STAFF REPORT

Administrative Amendments – 2025 Municipal Planning Strategy and Land Use By-law.

1-1

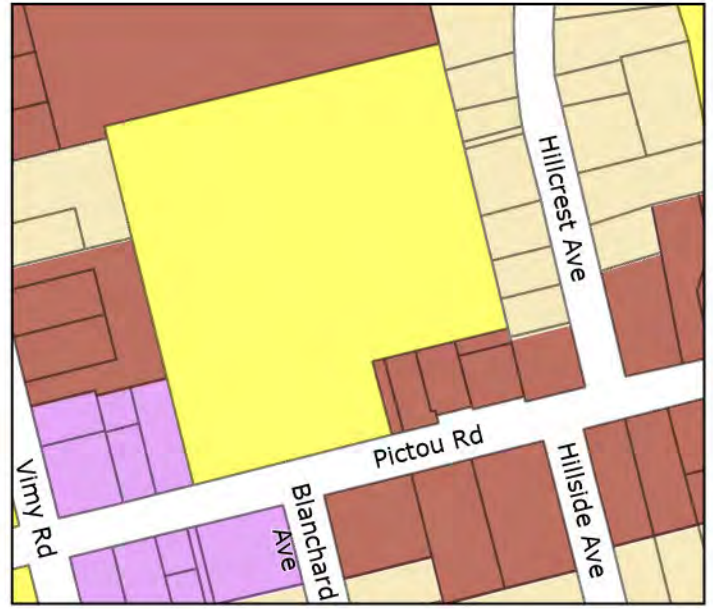
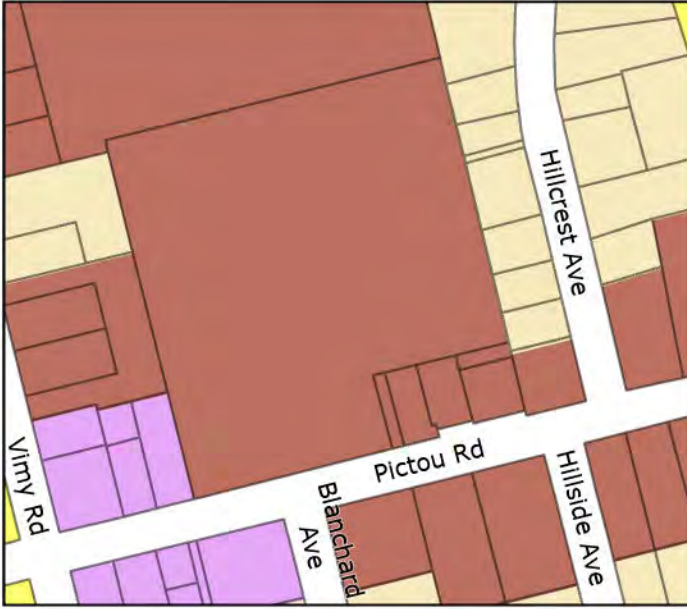
| Issue | Recommended Amendment |
|--|--|
| 1. Future Land Use Map (FLUM) for Bible Hill/Valley | 1-1 Bible Hill Elementary School on Pictou Rd, (PID 20068441) & 1 -2 Shannex (Vimy Court) on Vimy Rd (PID 20233029) need to change to Institutional from residential. 1-3 The Northumberland Lamb Marketing Co-Op (PID 20249892) needs to change to RLD (Low Density Residential) from CDD. It has historically been considered an existing non-conforming |

1-4

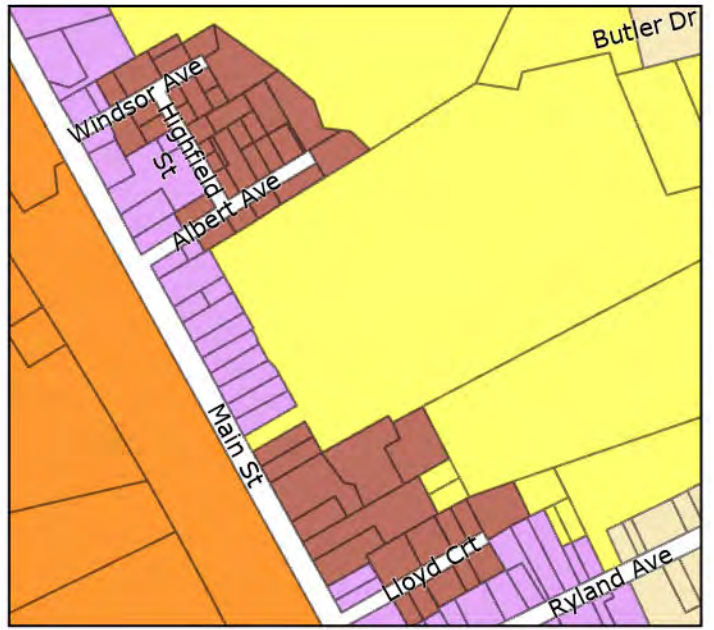
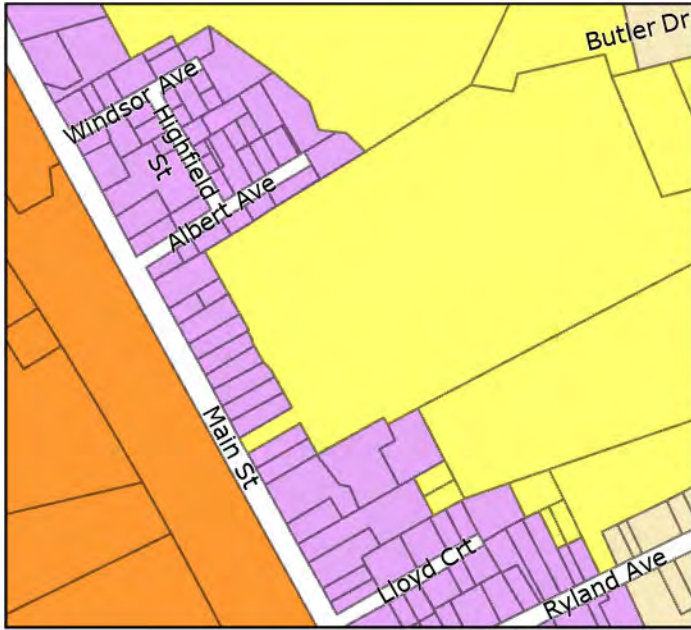
| Issue | Recommended Amendment |
|--|---|
| | <p>use at that location since the 1980's, which is why it has always been considered residential in previous plans & by-laws.</p> <p>Two areas to change to Residential Medium High Density from Commercial: 1-4 sections along & off Main St from Lloyd Court to Windsor Ave, excluding any existing businesses.</p> <p>1-5 sections along Pictou Rd: between Oak Drive & Village Court. 1-6 Lands on the west side of Pictou Road in East Mountain to go from C Commercial to RMHD Medium High Density Residential, reflecting what has been the development trend in recent years. From PID 20266276 to 20010922.</p> |

3-1

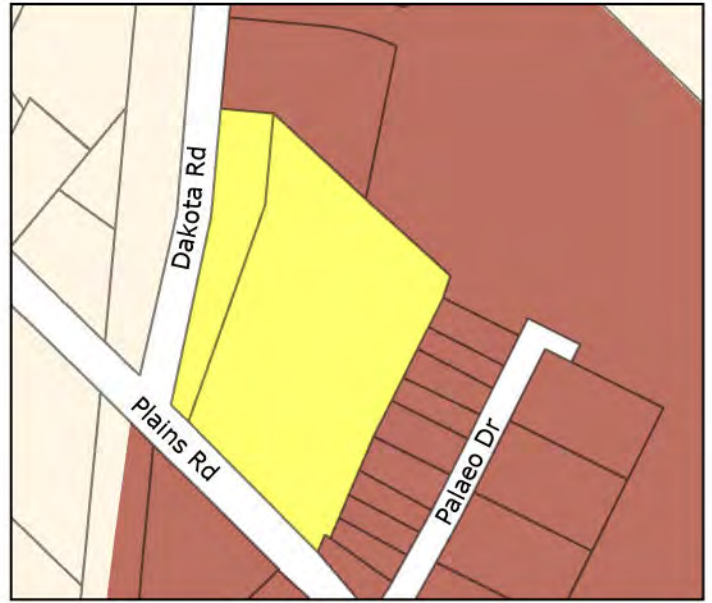
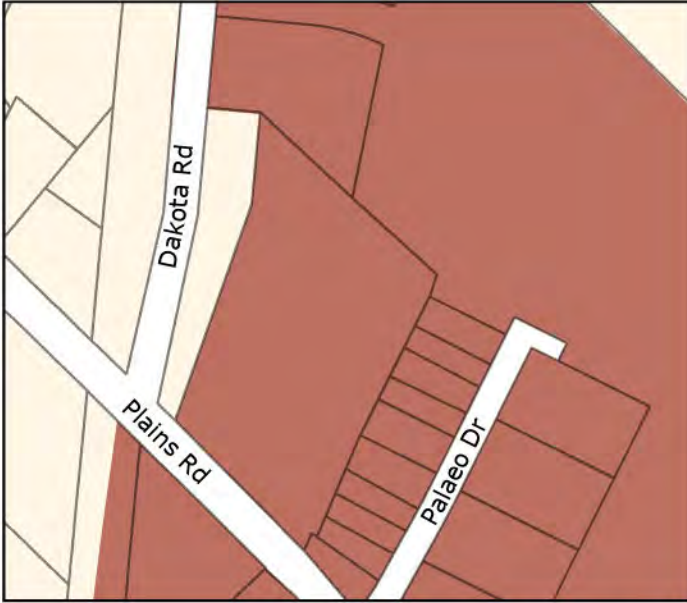
| Issue | Recommended Amendment |
|--|---|
| <p>3. FLUM for Debert</p> | <p>3-1 Shannex (Debert Court) PID 20451696 & 20452041 should be Institutional. 3-2 The six new homes on Dieppe Avenue should be residential (RMHD), not Parks & Open Space. PIDs: 20503595, 20503587, 20503579, 20503561, 20503553 & 20503546.</p> |

4-2

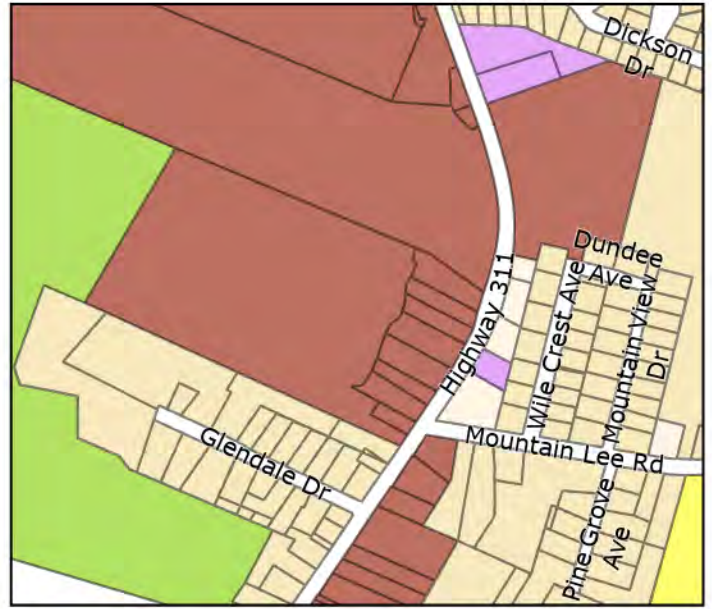
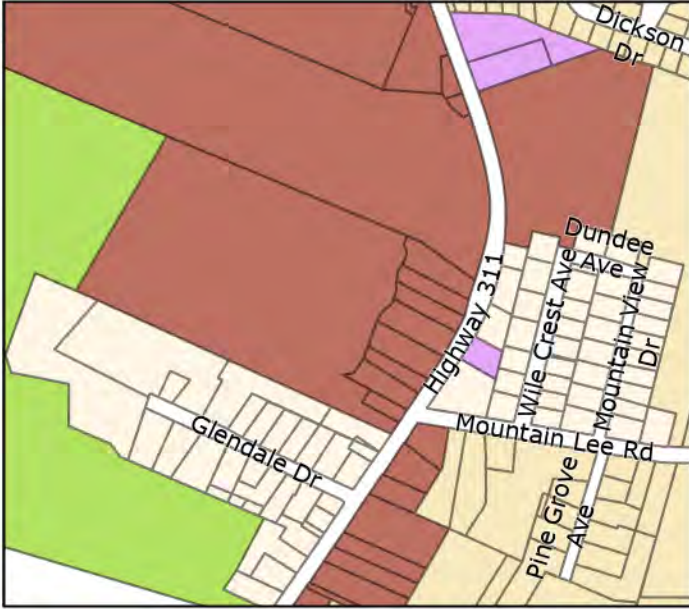
| Issue | Recommended Amendment |
|--|---|
| <p>4. FLUM for North River</p> | <p>4-1 The North River Elementary School (PID 20007134) should be Institutional not Rural.</p> <p>4-2 The Glendale Drive subdivision as well as Wile Crest Ave., Dundee Avenue & Mountain View Drive subdivision should be RLD (Low Density Residential) not Rural. These areas have access to central sewer.</p> <p>4-3 Lands recently acquired by the Municipality on Dickson Drive to become Institutional from RLD (Residential Low Density). The 4 PIDs are: 20375473, 20375507, 20439683 and 20246443.</p> |

1

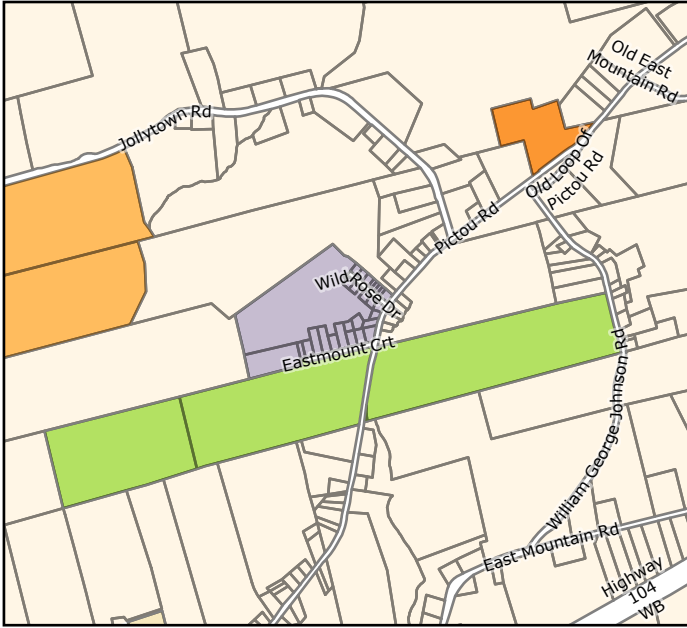
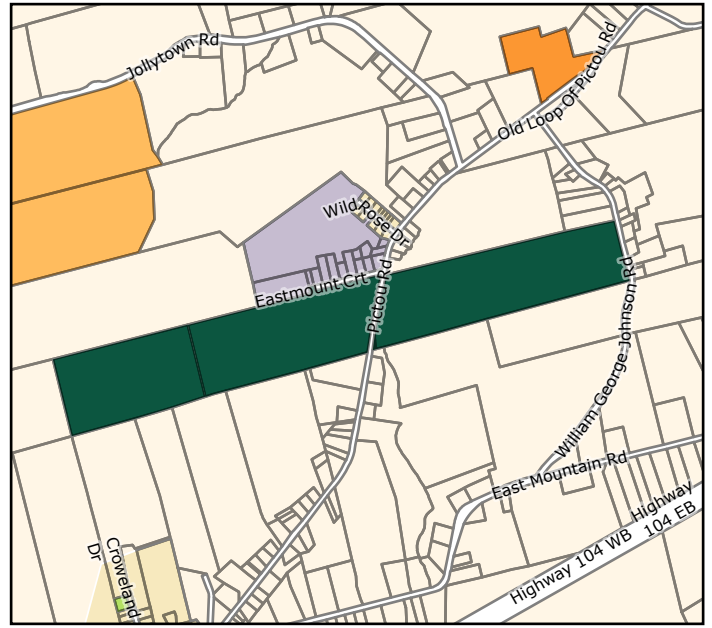
| Issue | Recommended Amendment |
|--|---|
| 1. Several commercial parks were incorrectly zoned P1, not P2. | Change the following PIDs to P2: 20282927, 20010740, 20443990, 20055281 |

7

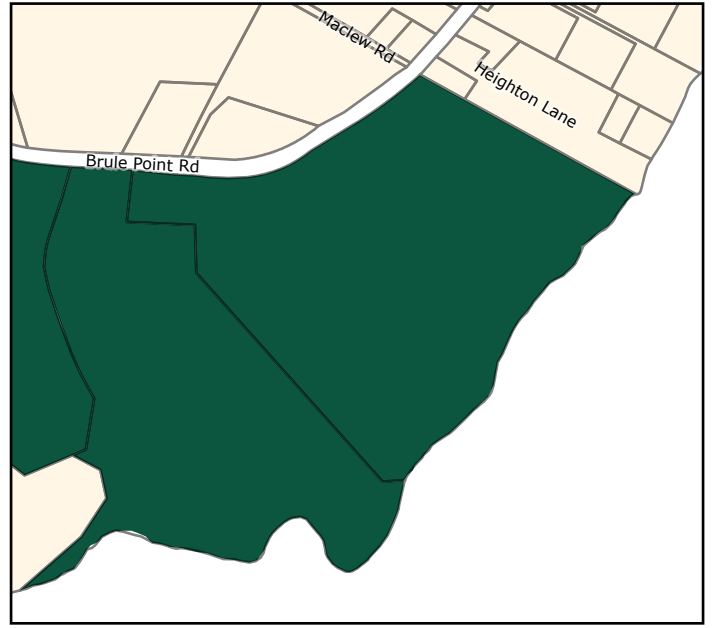
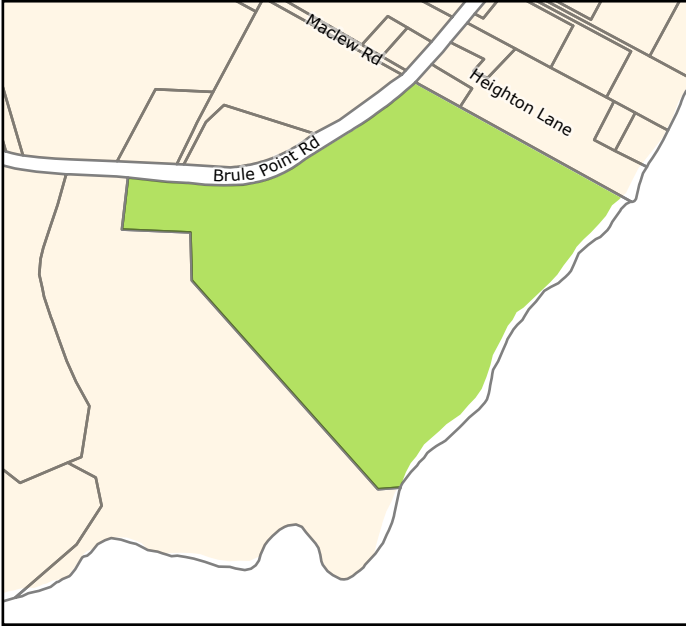
| Issue | Recommended Amendment |
|---|--|
| 7. Zoning Map – 36.1. Change Brule Point Golf Course from P1 & RG to P2 | PIDs 20467254 & 20021457 to change to P2 to reflect use of lands as an existing golf course. |

10

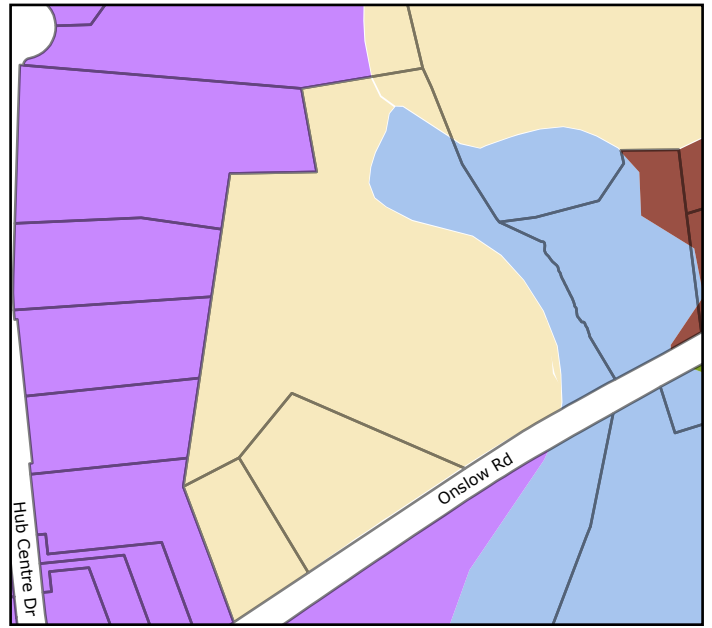
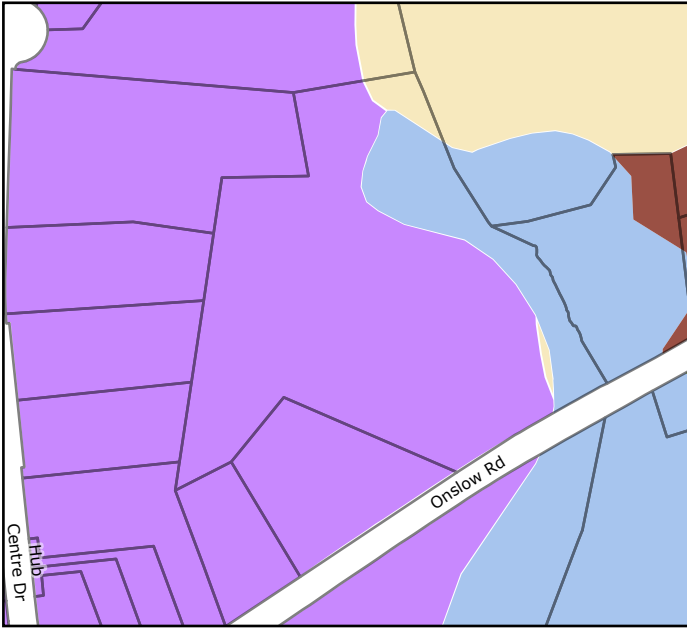
| Issue | Recommended Amendment |
|---|--|
| 10. 3 residential lots along Onslow Rd. in Upper Onslow to R2 from C2 | PIDs 20505871, 20106183 & 20283214 should be zoned residential, R2 not C2, Highway Commercial. |

20

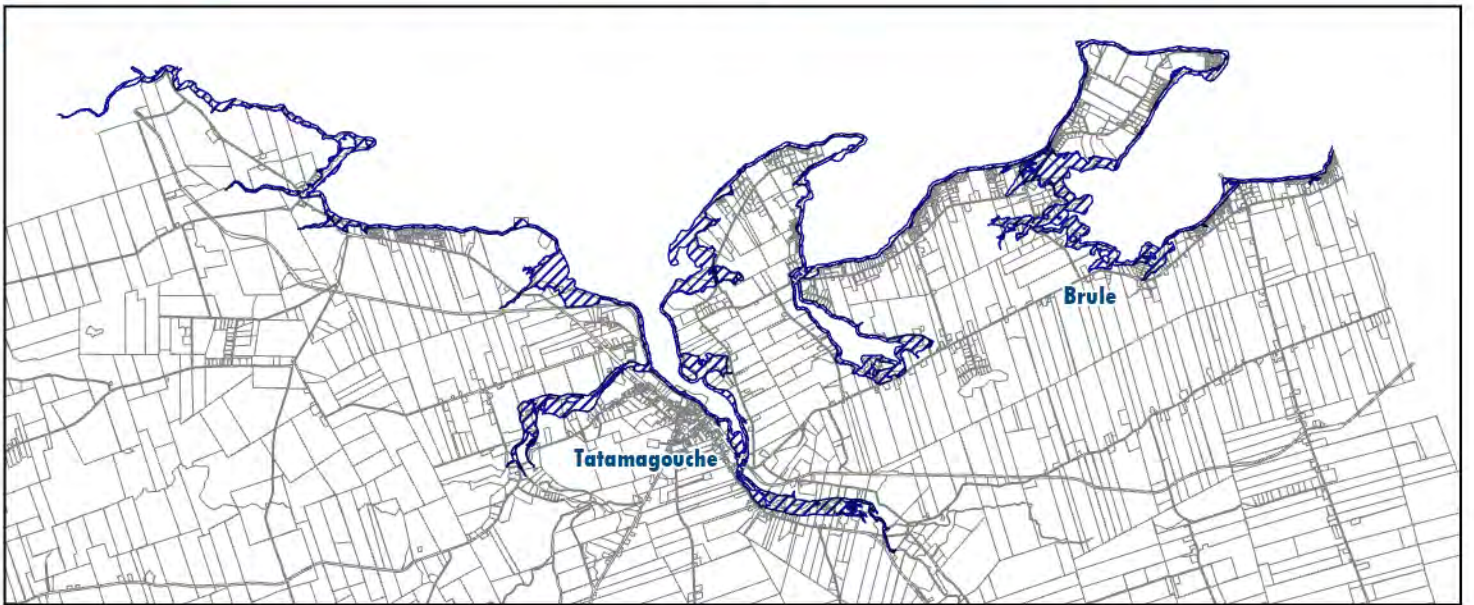
| Issue | Recommended Amendment |
|---|--|
| 20. Truro Hts Zoning map. The Waste Water Treatment Plant needs to be zoned Institutional, not AP. | These PIDs 20218137, 20314175 & 20213948 are to be zoned Institutional not Agriculture Potential. |

7-9

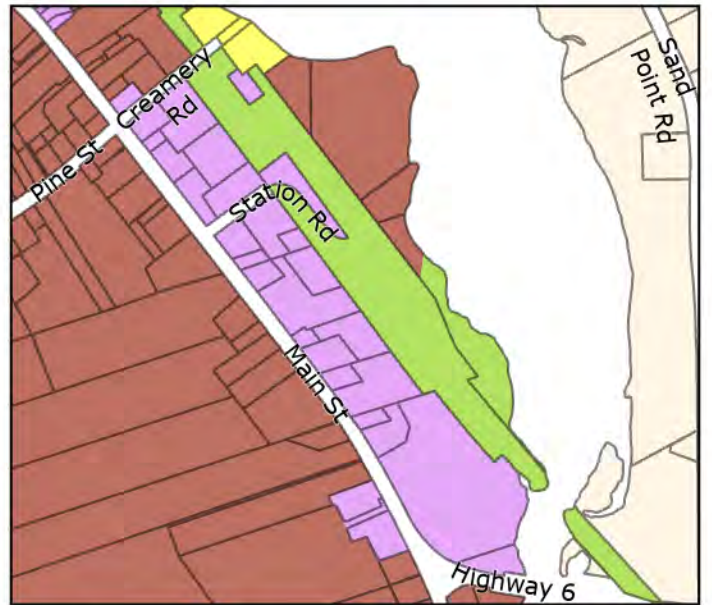
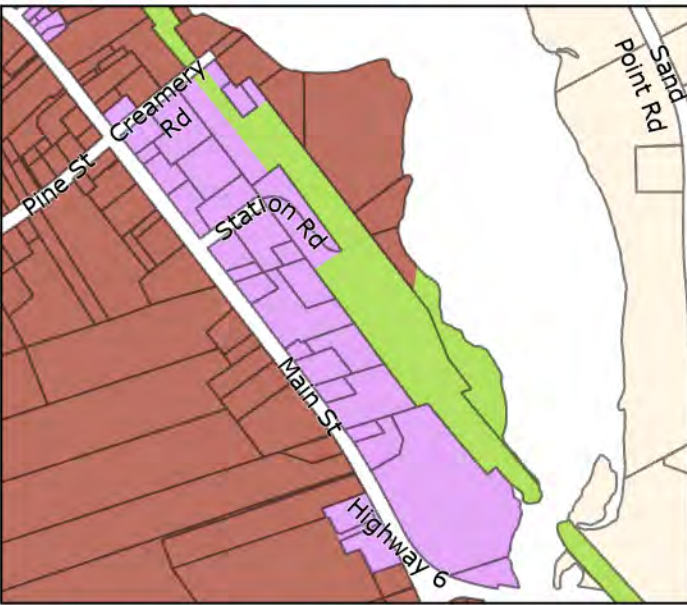
| Issue | Recommended Amendment |
|--|---|
| | <p>7-8 Adjustments are needed to Provincial owned lands – PID 20419735. Sections are wrongly shown as Commercial, not Parks & Open Space.</p> <p>7-9 Campbell's Shipyard Marina, PID 20486163 to be Parks & Open Space, not RMHD.</p> <p>7-10 Creamery Square properties to be Institutional, not RMHD. PIDs 20310587, 20489506 & 20085908.</p> <p>7-11 The Daycare on Blair Avenue to be Institutional, not RMHD. PID 20087870.</p> |

9-3

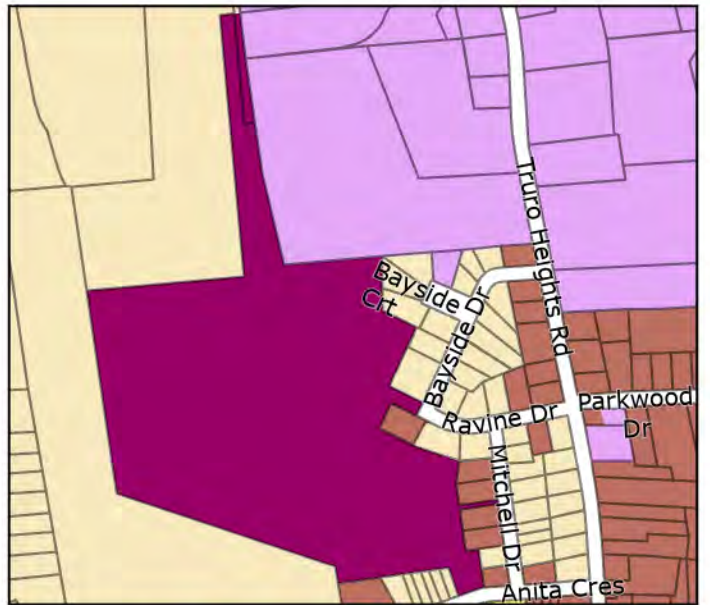
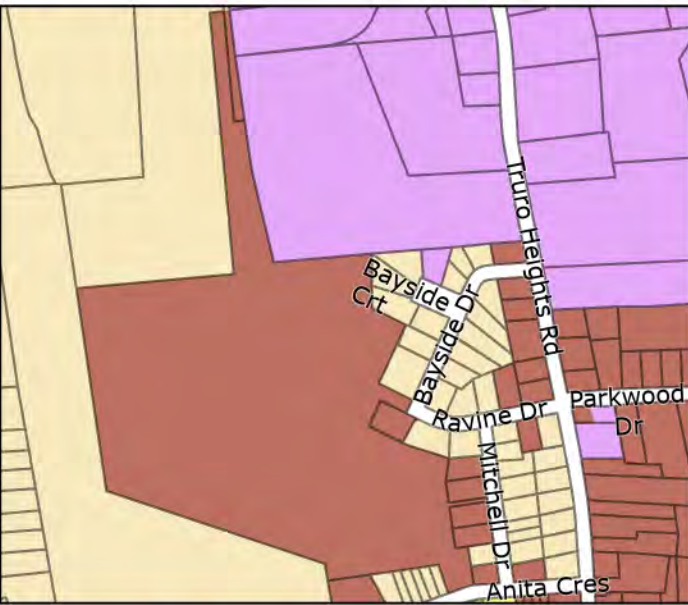
| Issue | Recommended Amendment |
|--|---|
| 9. FLUM for Truro Heights | <p>9-1 The waste water plant to be Institutional not AP. PIDs 20218137, 20314175 & 20213948.</p> <p>There are several errors on this map as it appears as though some zoning layers were used instead of FLUM designations. 9-2 PID 20409249 (former golf course) – to be CDD not RMHD. 9-3 PID 20284725 – existing commercial to stay as Commercial, not residential. 9-4 20216727 – partial commercial designation correct – just needs to be adjusted slightly and PID 20216719 to be RMHD, not commercial. 9-5 PID 20269379 - entire lot to be RLD. A portion of it is incorrectly designated as RMHD.</p> |
